ORIGINATION FORM

Proposed Revisions to a Standard Plans Index
(Please provide all information — Incomplete forms will be returned)

Index Number: 425-060

Index Title: Back of Sidewalk Drainage

INLET TYPE C (MODIFIED)

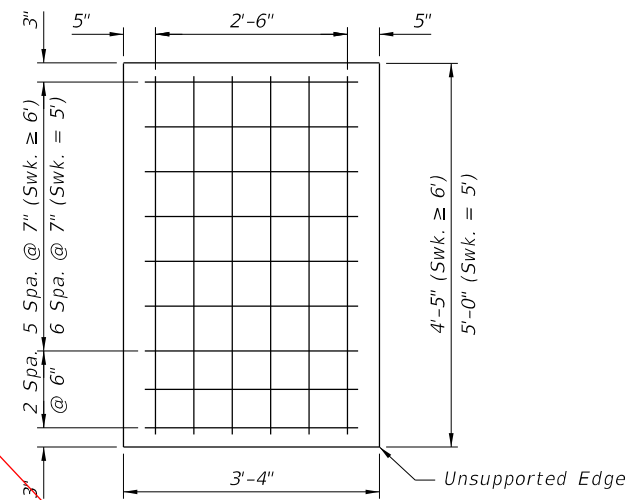
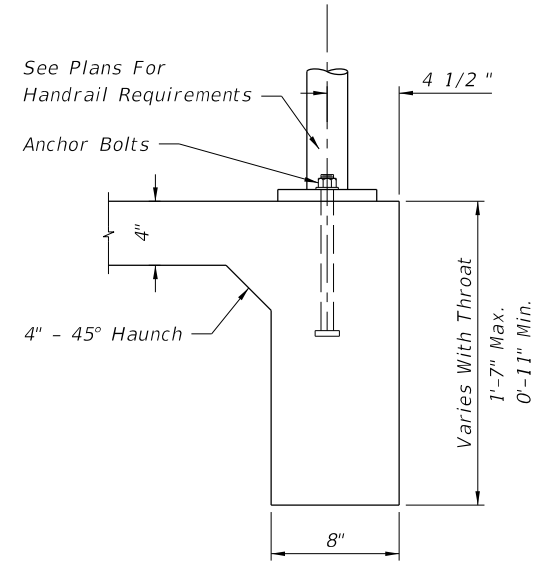
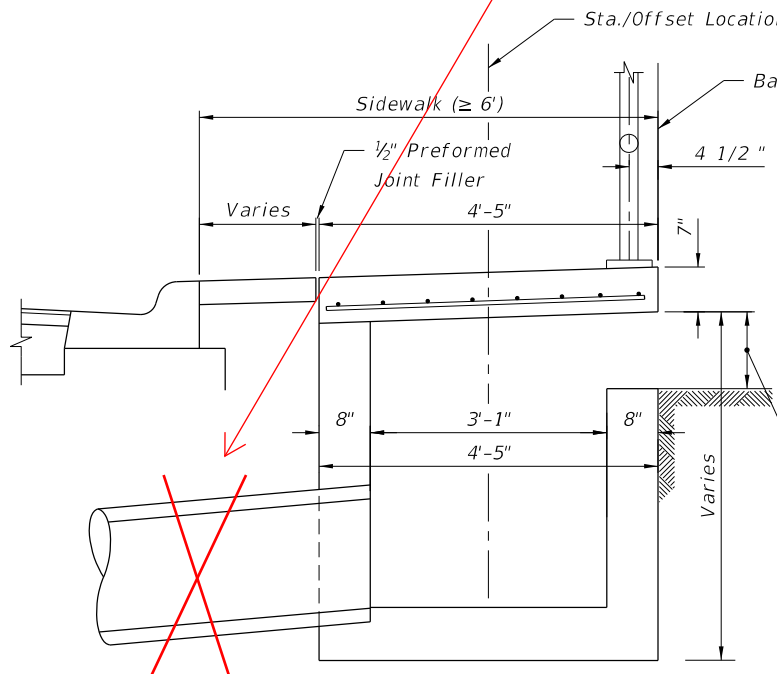
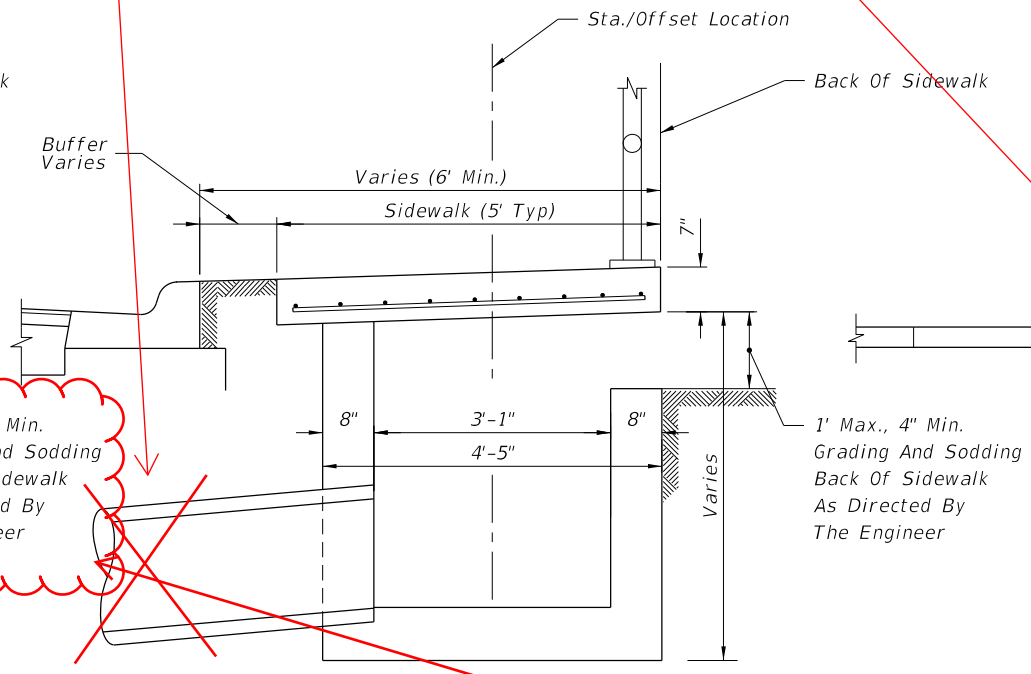
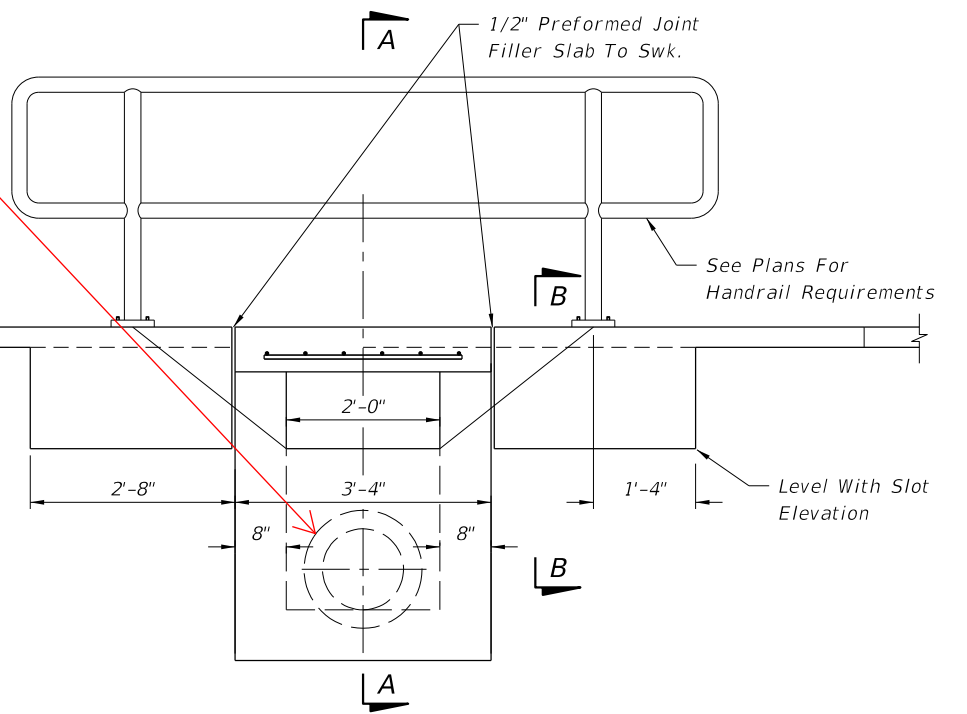
1. For additional details see Index 425-052. **Sheet 1**

2. Inlet to be paid for under the contract unit price for Inlets (Ditch Bottom Type C Modified), EA. Handrail to be paid for under the contract unit price for Pipe Handrail, (Material), LF. **SPI/Spec**

ADDED as Note 1
ADDED Note 2: Pipe connection not shown

Renumbered

SPECIAL CONCRETE ENDWALL

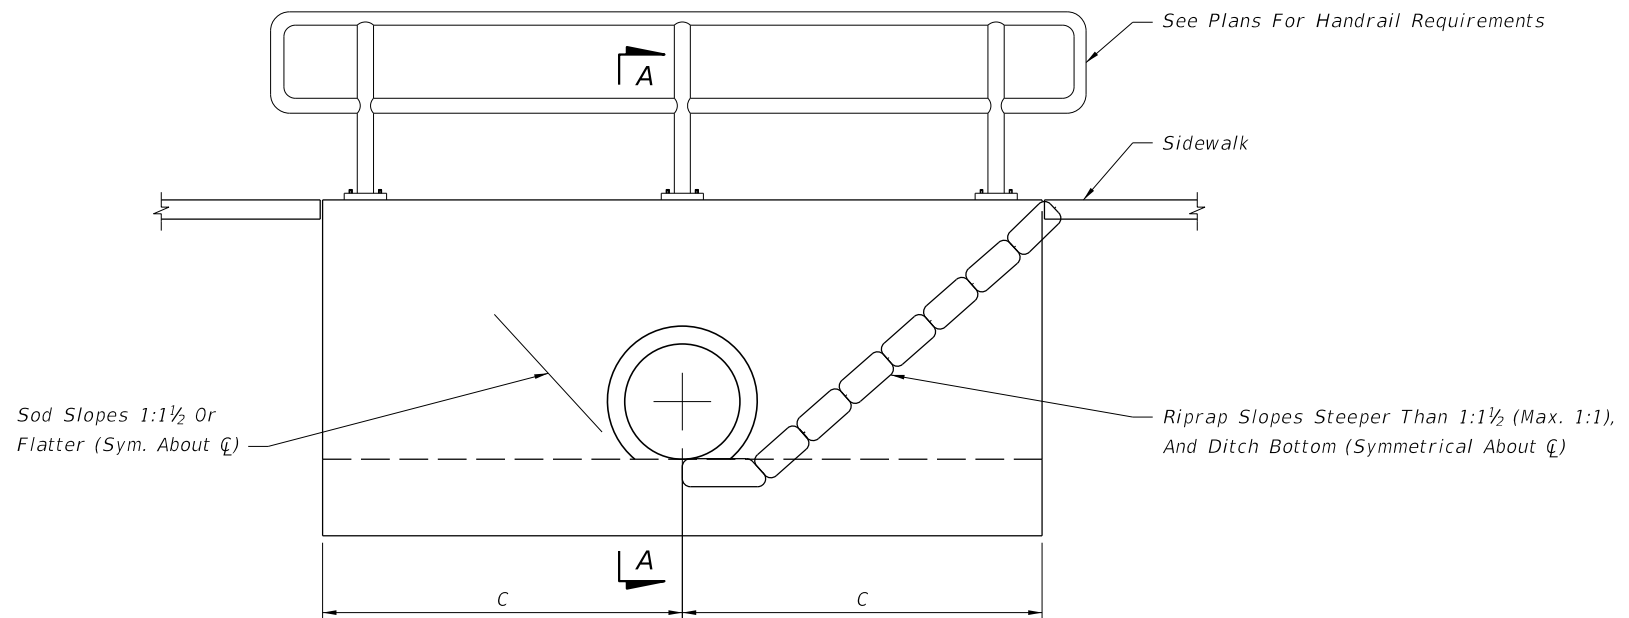
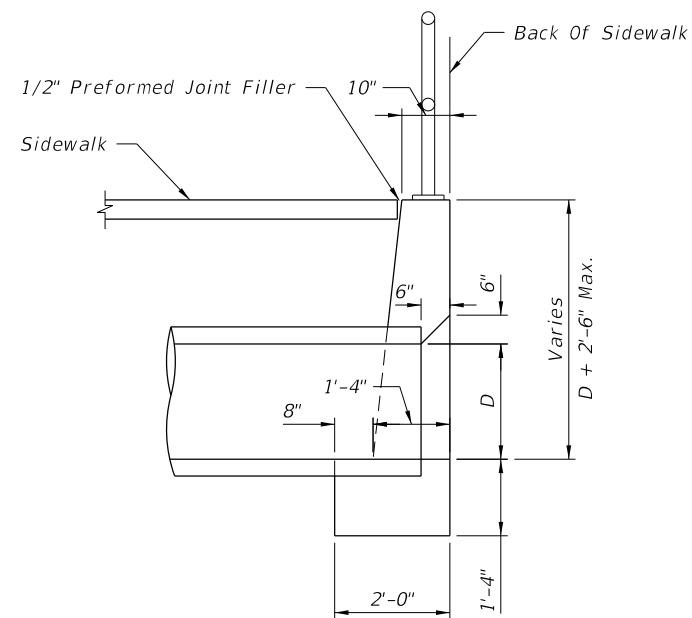
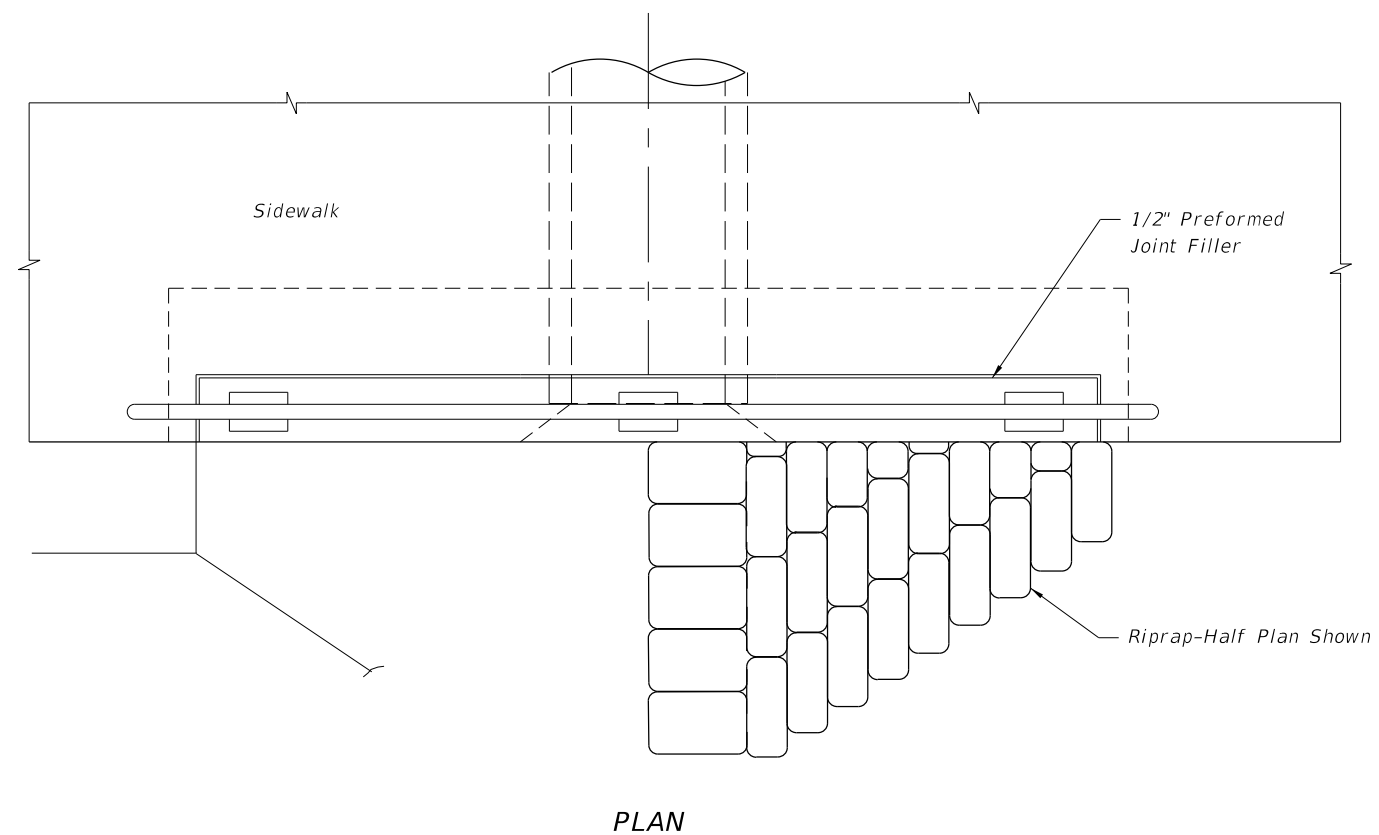
Reorganized and Added Section Detail for Handrail Anchor Bolt.

- Notes:
- Maximum pipe size shall be 24" diameter. **SPI**
 - Grading back of sidewalk varies and shall be done as directed by the Engineer.
 - Concrete quantities shown are for maximum wall heights, and shall be basis for estimate and payment.
 - Riprap quantities shown are for estimate purposes only. Cost of riprap to be included in cost of the endwall.
 - Endwalls to be paid for under the contract unit price for Concrete Class I (Endwalls), CY. Handrail to be paid for under the contract unit price for Pipe Handrail, (Material), LF. **SPI/Spec**

YARD DRAINS

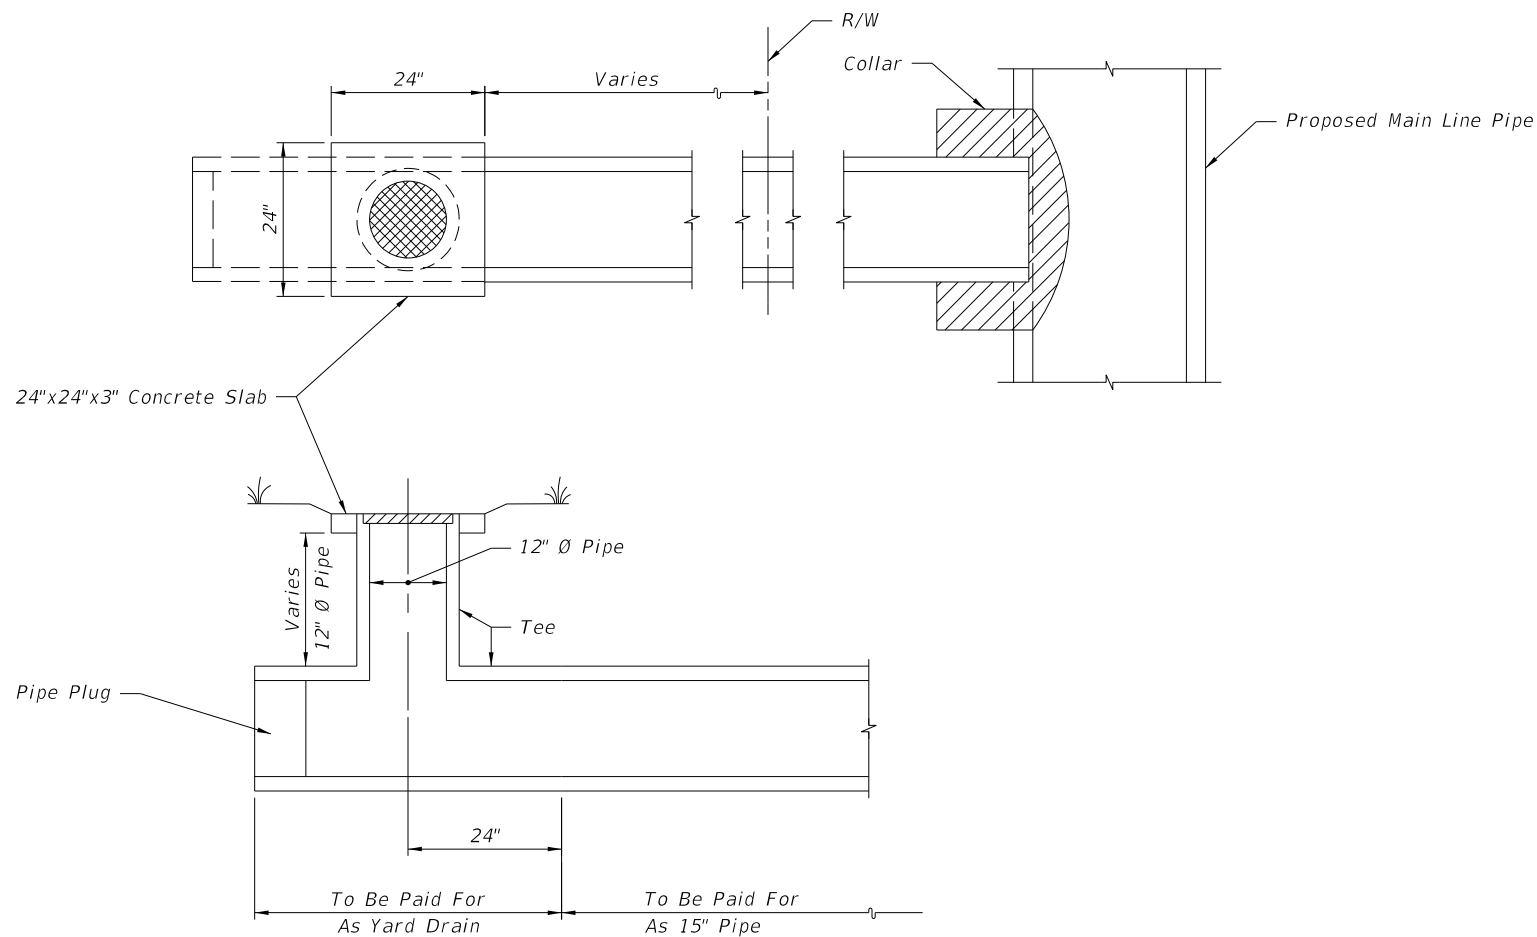
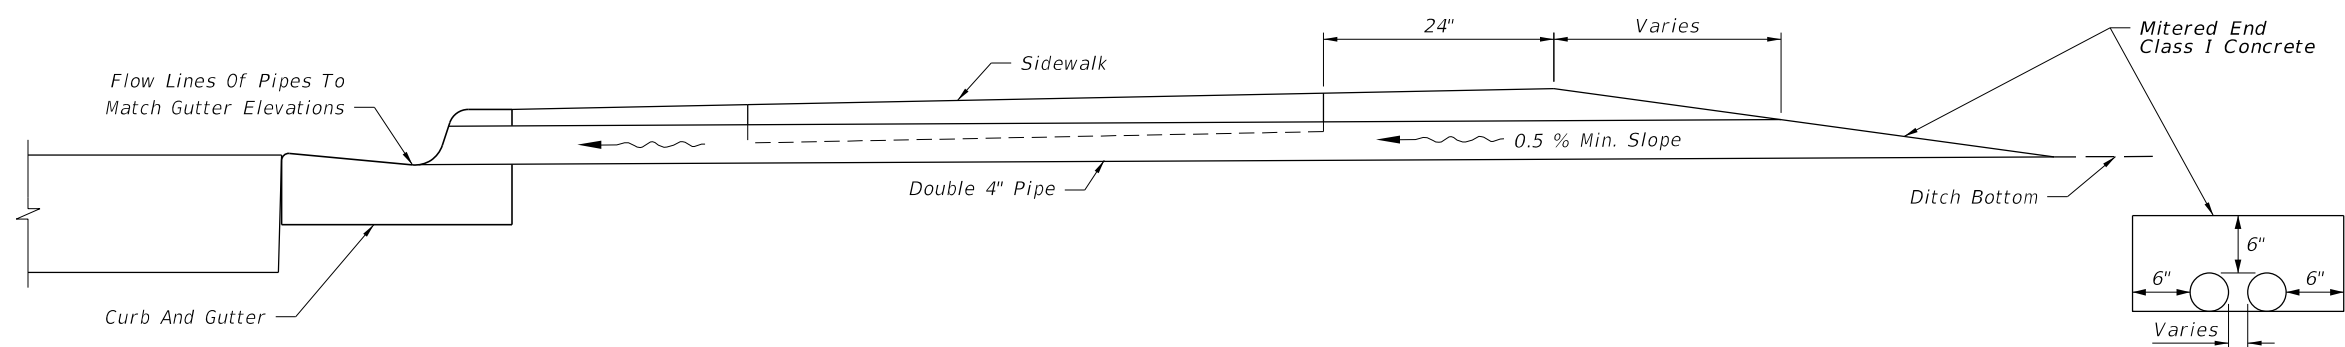
- Notes:
1. Yard drains to be located outside the R/W. Drainage area should not exceed 750 SF (grate flow 0.1 Cfs). **SPI**
 2. Yard drains may be constructed at the option of the property owner as shown on the plans.
 3. Cost of plugs and collars to be included in the cost for 15" pipe. For collar and plug details see Index 430-001.
 4. Yard drains to be paid for under the contract unit price for Yard Drains, EA. **SPI/Spec**

- Notes:
1. To be constructed at locations as directed by the Engineer.
 2. Either cast iron pipe or PVC rigid conduit, U.L. listed for direct sunlight exposure, Schedule 40, may be used.
 3. Pipe and Mitered End to be paid for under the contract unit price for either Cast Iron Soil Pipe (Standard) (4"), LF or PVC Pipe For Back Of Sidewalk Drainage (4"), LF. **SPI/Spec**
